Submissions Report

Warehouse and Distribution Centre

805-817 Mamre Road, Kemps Creek

SSD-30871587

Figure 1 Typical section – OSER

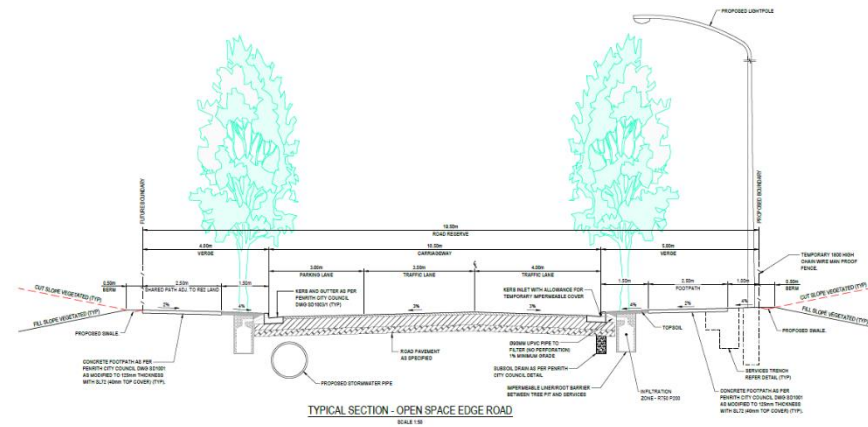
- Respond to the issues raised by Penrith City Council in their comments on the EIS
- Describe how the road location is consistent with the objectives of the RE1 zone and clarify implications for the acquisition of this land as identified under State Environmental Planning Policy (Industry and Employment) 2021 (Industry and Employment SEPP)
- Demonstrate how the proposed relocation of the edge road satisfies Control 7 of Section 3.4.1 of the MRP DCP
- Provide evidence of consultation with adjoining landowners that will be impacted by the realignment of the edge road that clearly demonstrates acknowledgement of any implications for future development of those particular properties
- Provide details on the timing and delivery of this road
- Provide detailed design drawings that are consistent with Table 9 and Figure 16 of the MRP DCP.

- Design of the OSER has been provided as part of the Revised Civil Engineering package at **Appendix C**.
- Detailed design drawings that are consistent with Table 9 and Figure 16 of the MRP DCP are available at Drawing Number 21-894-C1005 of the Revised Civil Engineering Package available at

Appendix C and is reproduced in **Figure 1** below.

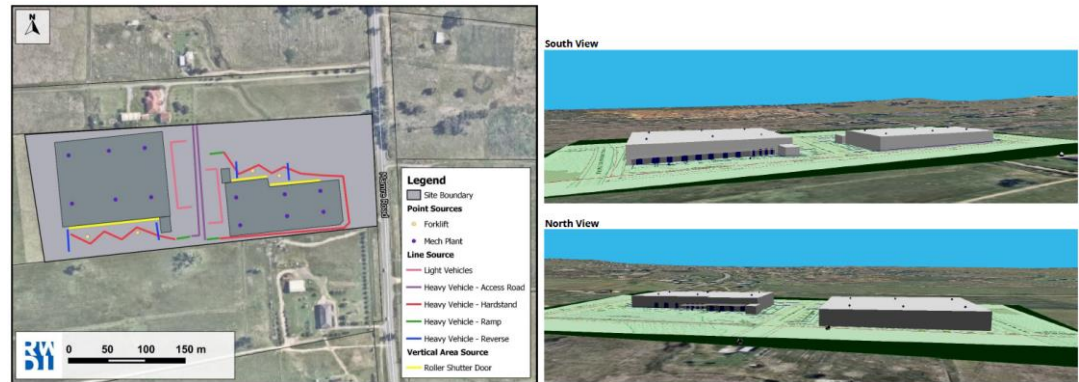
- screening effects from buildings and barriers i.e. proposed awnings and other industrial buildings in the MRP
- ground topography
- ground absorption and atmospheric absorption

Screenshots of the 3D model has been provided at Appendix B of the NIA, and are provided below as evidence of the listed factors being considered in the modelling:
